SUBJECT: Entergy Nuclear Operations, Inc.  
Pilgrim Nuclear Power Station  
Docket No. 50-293  
License No. DPR-35

Proposed Change to Applicability of Pilgrim's Pressure-Temperature Curves as Described in Technical Specification Figures 3.6.1, 3.6.2, and 3.6.3, Revision 1

LETTER NUMBER: 2.02.100

**PROPOSED TECHNICAL SPECIFICATIONS CHANGES  
(MARK-UP)**

**PILGRIM REACTOR VESSEL PRESSURE-TEMPERATURE LIMITS**  
**HYDROSTATIC AND LEAK TESTS**

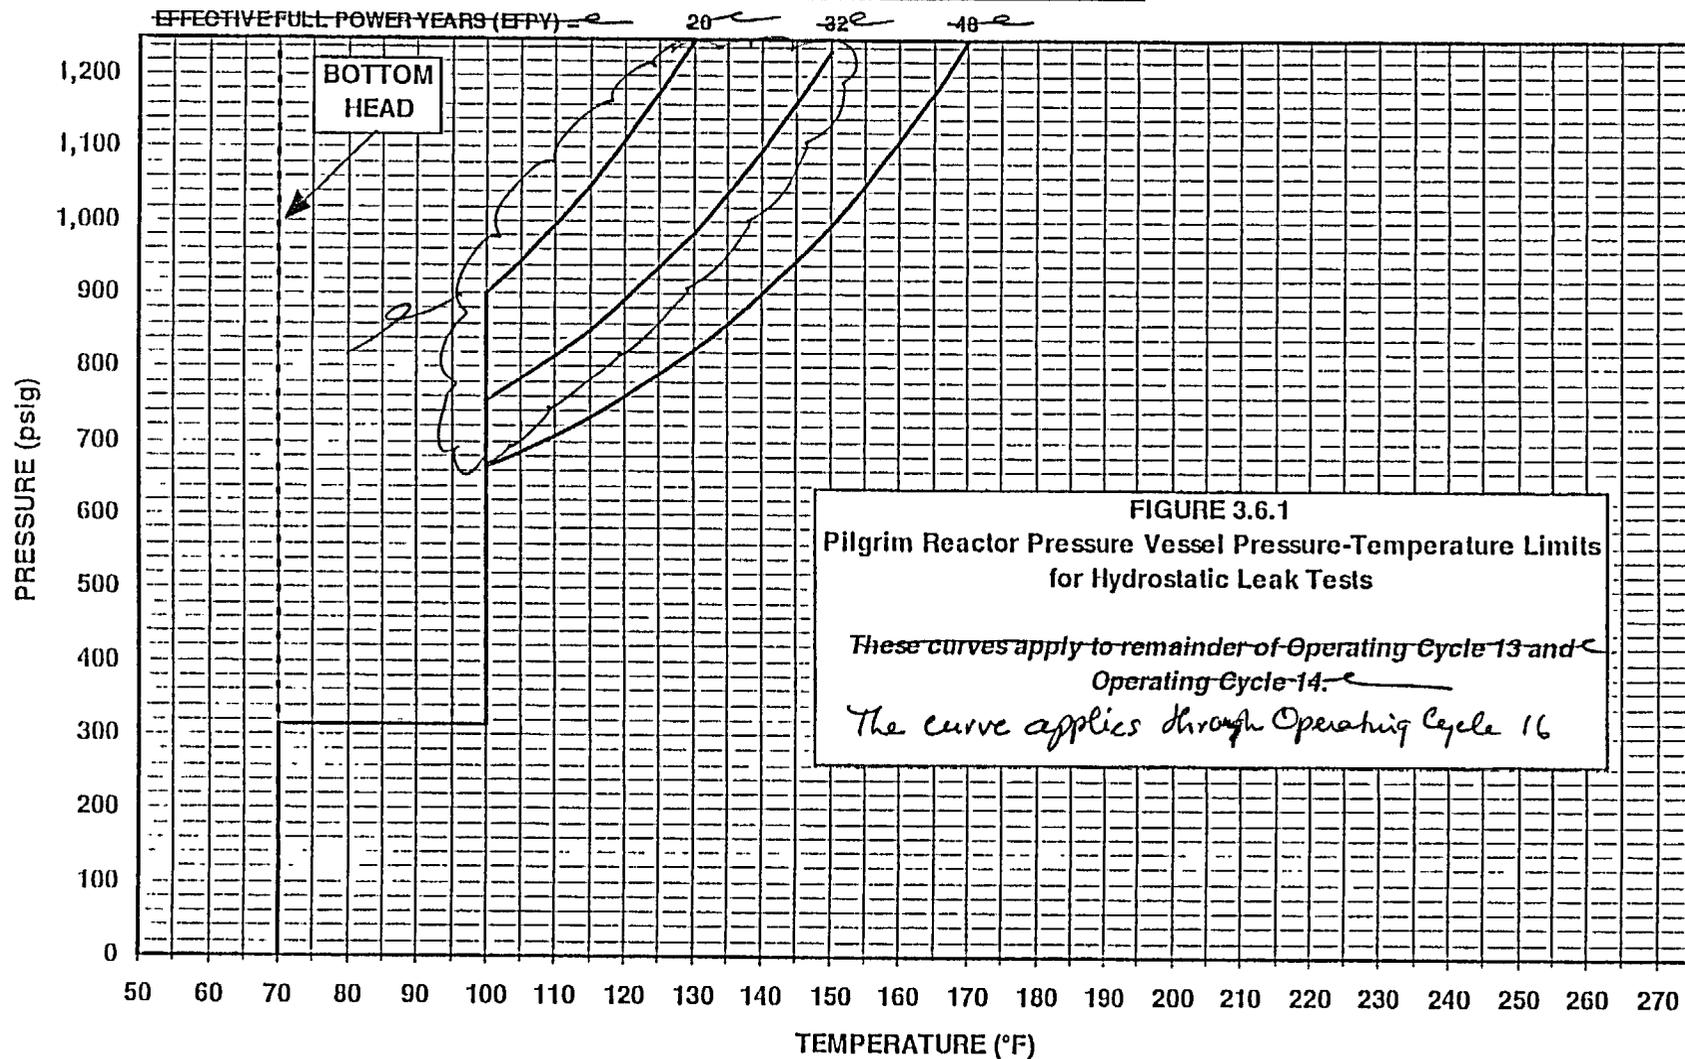
"These curves apply to remainder of Operating Cycle 13 and Operating Cycle 14".

"The curve applies through Operating Cycle 16."

The proposed change deletes the 20 and 32 EFPY curves and removes the EFPY designators from the graph.
